Access Compliance Report

Public Rights-of-Way

Intersection ID: 50706	Main Street: GENERATIONS_ST	Cross Street: BROTHERLY_LN	Location: NE
ADA ID: 04E0204C64CC	Ramp Type: PerpDiag	Initial Pass/Fail: Fail	Overall Compliance: No
		Severity Score: 25

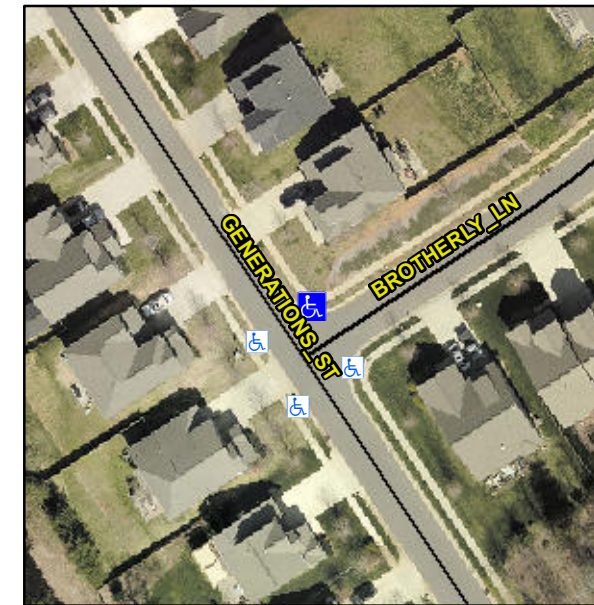
Not Found, R304.5.3

Compliance	Description	Data	Compliance	Description	Data
N/A	Ramp Length (in)	50.0	Yes	Ramp Slope (%)	6.8
Yes	Ramp Width (in)	48.0	No	Ramp XSlope (%)	7.5
N/A	Flare Type LT	N/A	N/A	Flare Type RT	N/A
N/A	Flare Slope LT (%)	N/A	N/A	Flare Slope RT (%)	N/A
N/A	Flare Traversable LT?	N/A	N/A	Flare Traversable RT?	N/A
N/A	Landing Length (in)	N/A	N/A	DWS Provided?	N/A
N/A	Landing Width (in)	N/A	N/A	DWS Contrast?	N/A
N/A	Landing Slope (%)	N/A	N/A	DWS Length (in)	N/A
N/A	Landing X Slope (%)	N/A	N/A	DWS Full Width?	N/A
N/A	Landing Curb? (Y/N)	N/A	N/A	DWS Offset (in)	N/A
N/A	Shared Landing?	N/A			
N/A	Gutter Ponding?	N/A	N/A	Gutter Slope (%)	N/A
N/A	Gutter Lip Ht (in)	N/A	N/A	Gutter X Slope (%)	N/A
N/A	Painted X Walk1?	No	N/A	Painted X Walk2?	No
	X Walk 1 Direction	To SE		X Walk 2 Direction	To SW
N/A	X Walk 1 Width (in)	N/A	N/A	X Walk 2 Width (in)	N/A
	X Walk 1 Slope (%)	3.7		X Walk 2 Slope (%)	3.6
	X Walk 1 X Slope (%)	6.1		X Walk 2 X Slope (%)	5.5

Remove & Replace Curb Ramp With Two New Directional Ramps or Equivalent.
